10.2 Turbine Generator

The information in this section of the reference ABWR DCD, including all subsections, tables and figures, is incorporated by reference with the following departures and supplements.

Figure 10.2-1 Turbine Stop Valve Closure Characteristic

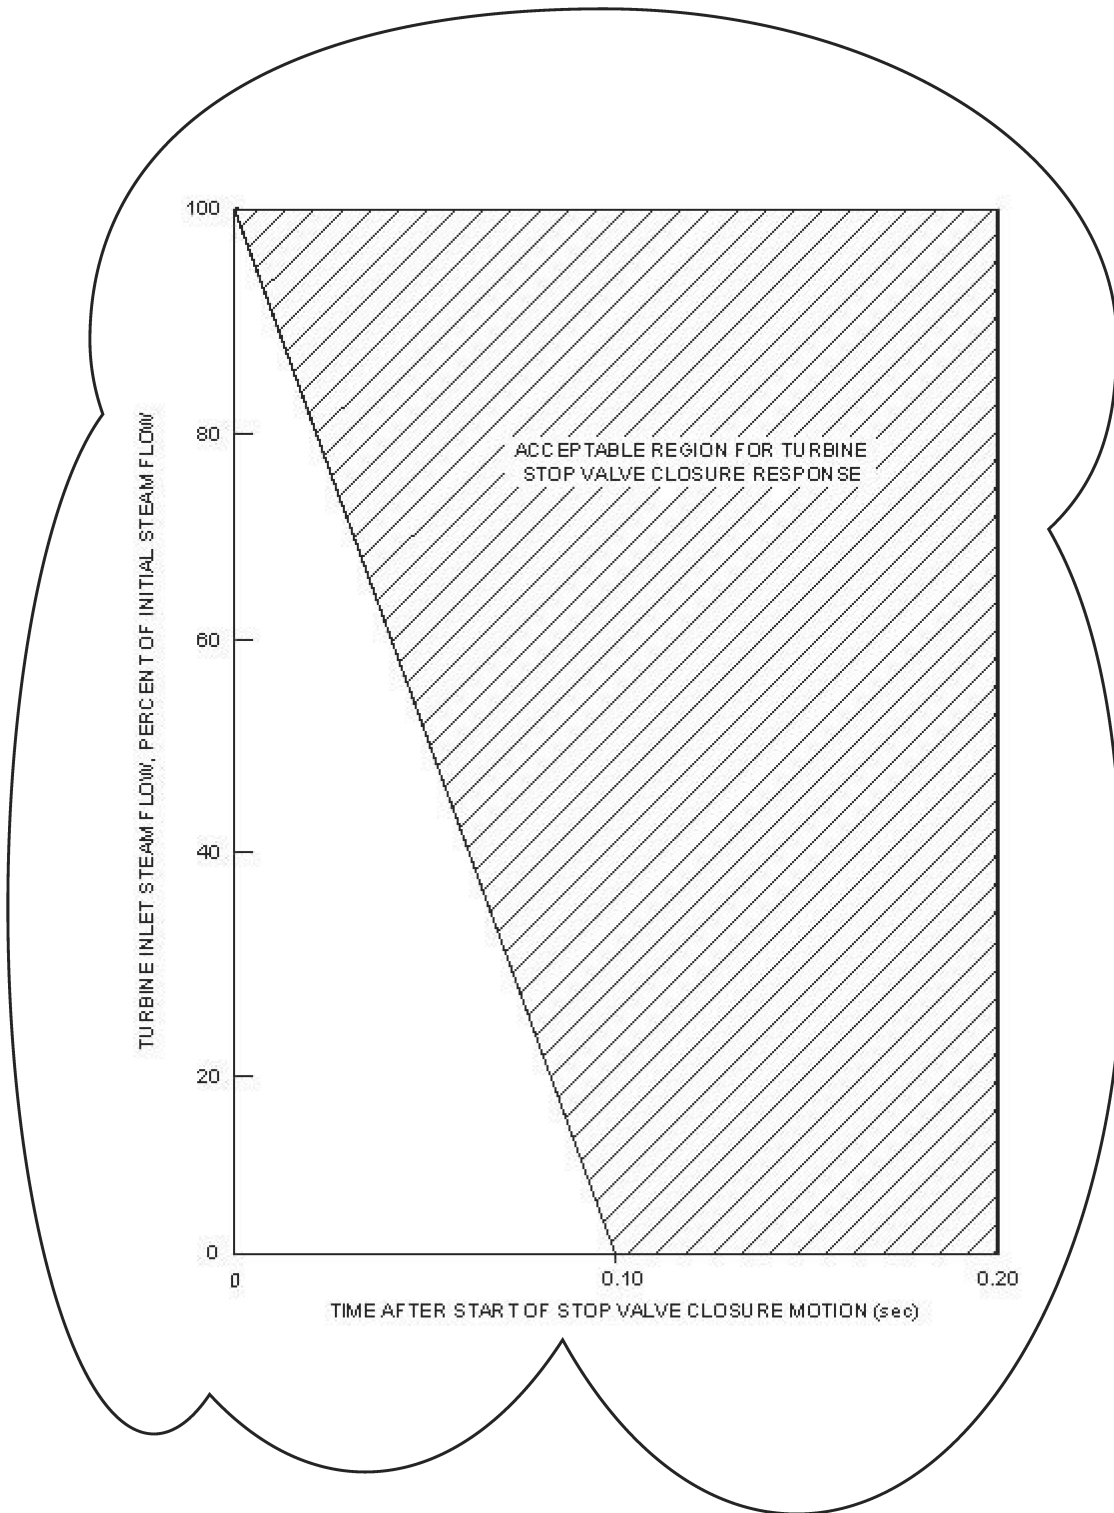
STD DEP Admin (Figure 10.2-1)

Figure 10.2-4 Generator Hydrogen and CO₂ System

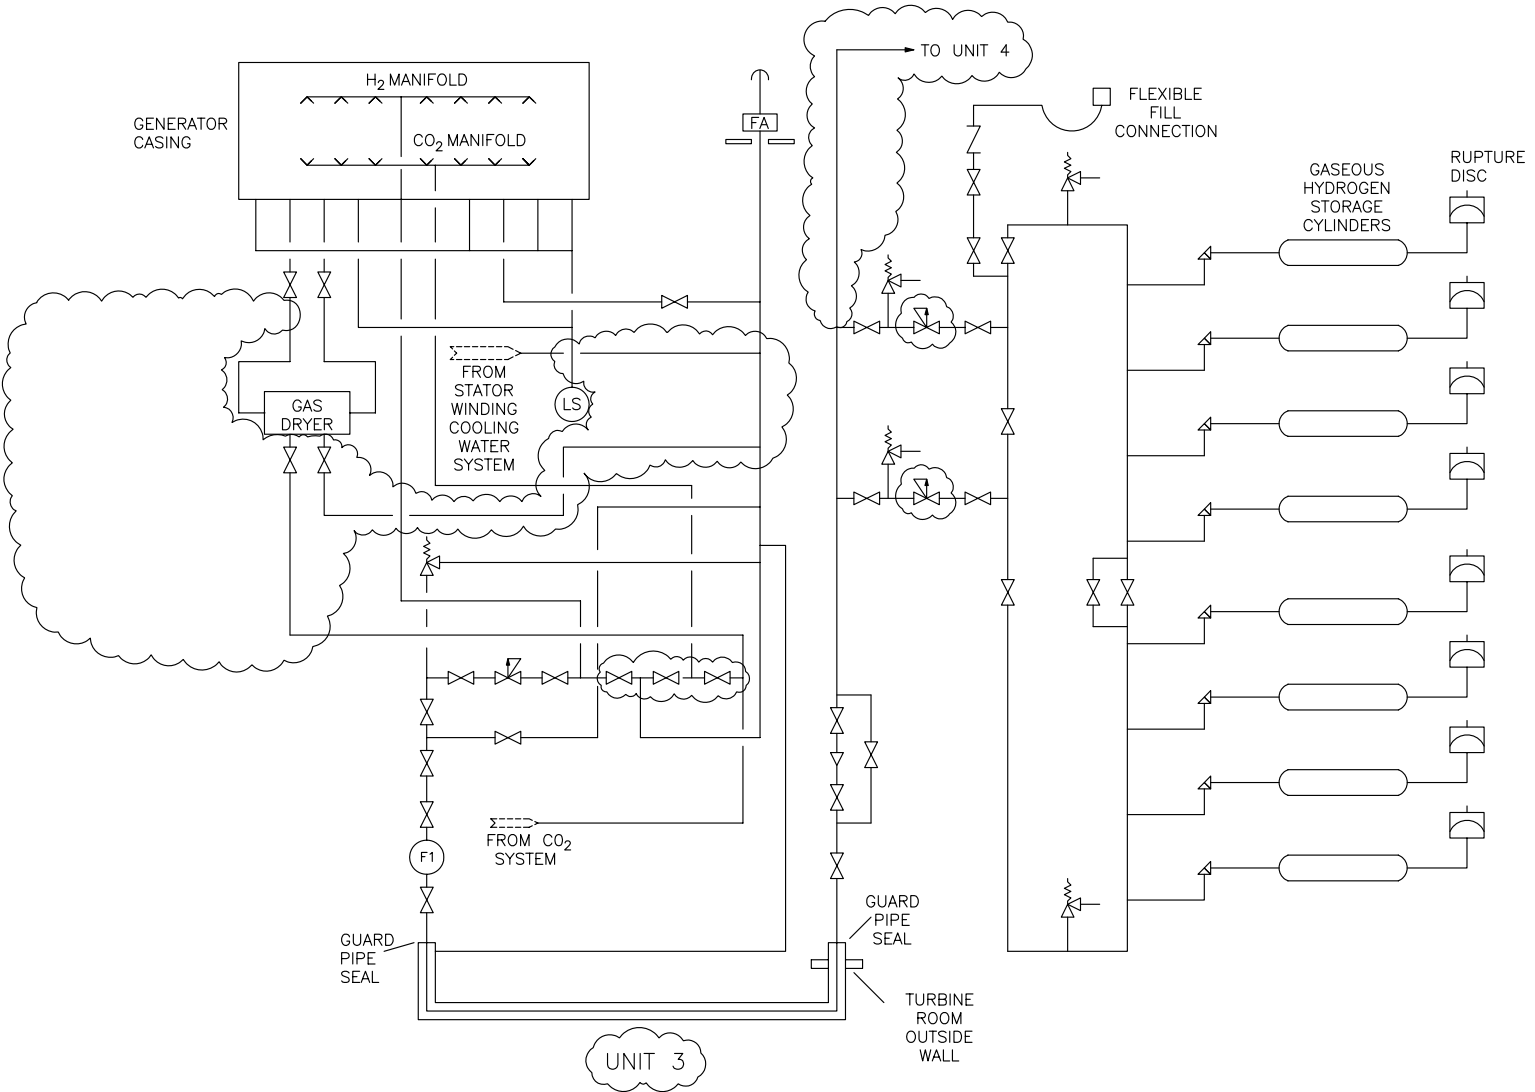
STP DEP 1.1-2 (Figure 10.2-4)

STP DEP 10.2-1 (Figure 10.2-4)

Bulk Hydrogen System—The bulk hydrogen and CO₂ system is illustrated on Figure 10.2-4. The hydrogen system is designed to provide the necessary flow and pressure at the main generator for purging carbon dioxide during startup and supply makeup hydrogen for generator leakage during normal operation.

The bulk hydrogen system utilizes the guidelines given in EPRI report NP-5283-SR-A with respect to these portions of the guidelines involving hydrogen that do not deal specifically with the HWC system. Specifically, the bulk hydrogen system piping and components will be located to reduce risk from their failures. A single bulk hydrogen storage facility will be used to store hydrogen compressed gas cylinders for STP 3 & 4. The bulk hydrogen storage is located outside ~~but near~~ the Turbine Building and at least 100m from any safety-related building. The hydrogen lines are provided with a pressure reducing station that limits the maximum flow to less than 100 standard cubic meters per minute before entering the Turbine Building. Equipment and controls used to mitigate the consequences of a hydrogen fire/explosion will be designed to be accessible and remain functional during the postulated postaccident condition. The design features and/or administrative controls shall be provided to ensure that the hydrogen supply is isolated when normal building ventilation is lost.
